**Identification cards — Contactless
integrated circuit cards — Proximity
cards —**

**Part 3:
Initialization and anticollision**

**AMENDMENT 1: Electromagnetic
disturbance handling and single-size unique
identifier**

Amendment 1 to ISO/IEC 14443-3:2011 was prepared by Joint Technical Committee ISO/IEC JTC 1, *Information technology*, Subcommittee SC 17, *Cards and personal identification*.

Figure 1 — Frame delay time PCD to PICC

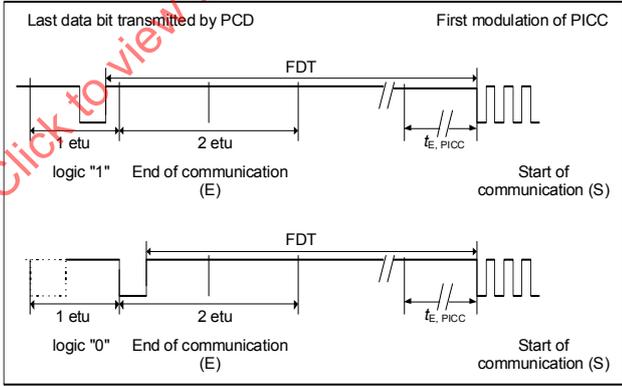
Page 7, 6.2.1.1

Replace Figure 1 with the following:

NOTE $t_{E,PICC}$ is specified in Clause 8.

Figure 17 — Timing before the PICC SOF

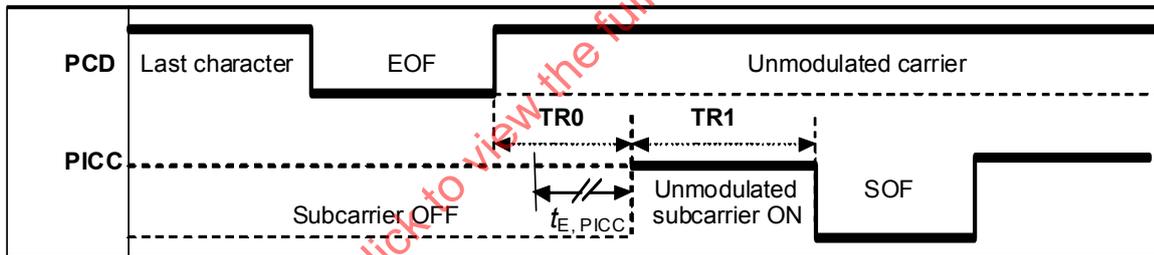
Replace Figure 17 with the following:

NOTE $t_{E,PICC}$ is specified in Clause 8.

Figure 33 — Low EMD time

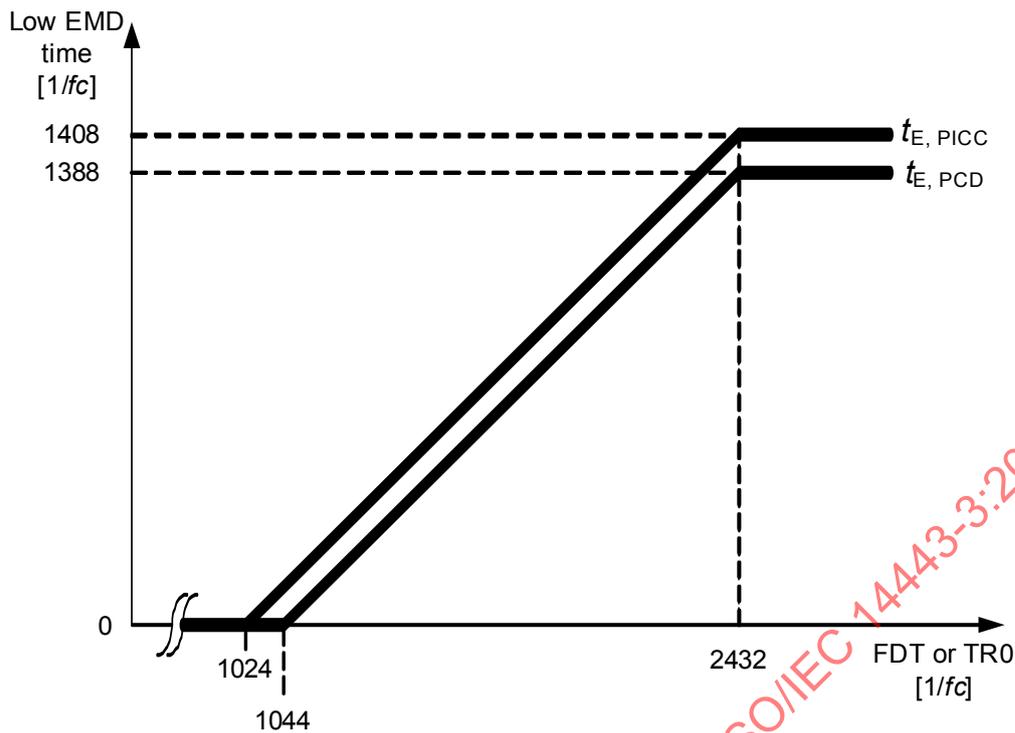
The low EMD time $t_{E,PICC}$ is the time period before the start of PICC data transmission, when the PICC shall not produce an EMD level higher than the EMD limit as defined in ISO/IEC 14443-2/Amd.1.

This low EMD time $t_{E,PICC}$ has a value of $F - 1024/fc$ with a maximum value of $1408/fc$ where F equals FDT for Type A and $TR0$ for Type B. The value is $0/fc$ for $TR0 \leq 1024/fc$.

The low EMD time $t_{E,PCD}$ is the time period to allow the PCD to recover from electromagnetic disturbances.

The PCD shall be ready to process a PICC frame no later than $t_{E,PCD}$ after the last time the EMD level was above the EMD limit as defined in ISO/IEC 14443-2/Amd.1.

This low EMD time $t_{E,PCD}$ has a value of $F - 1044/fc$ with a maximum value of $1388/fc$ where F equals FDT for Type A and $TR0$ for Type B. The value is $0/fc$ for $TR0 \leq 1044/fc$.

The low EMD time for PCD and PICC are illustrated in Figure 33.
